Access Compliance Report Public Rights-of-Way (Curb Ramps)

Main Street: HEDLUND_DR Cross Street: CERRITOS_AVE Location: NE

ADA ID: RPAT220203131450 Ramp Type: Type 4 - Parallel Initial Pass/Fail: Pass Overall Compliance: No Severity Score: 0

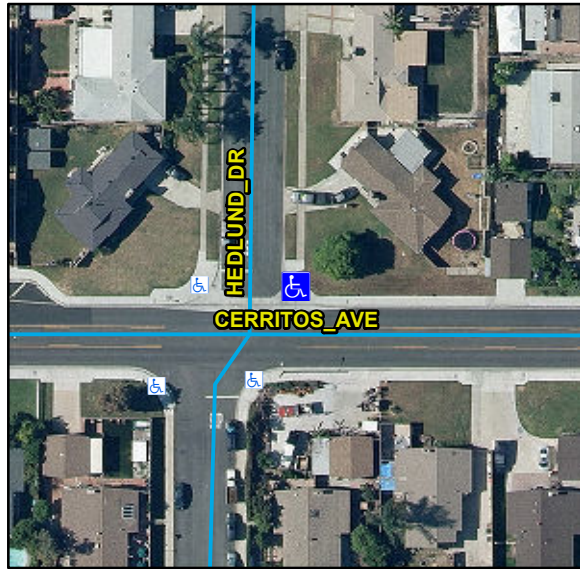
Surveyor Notes:

N/A

Possible Solutions:

Remove & Replace Landing.
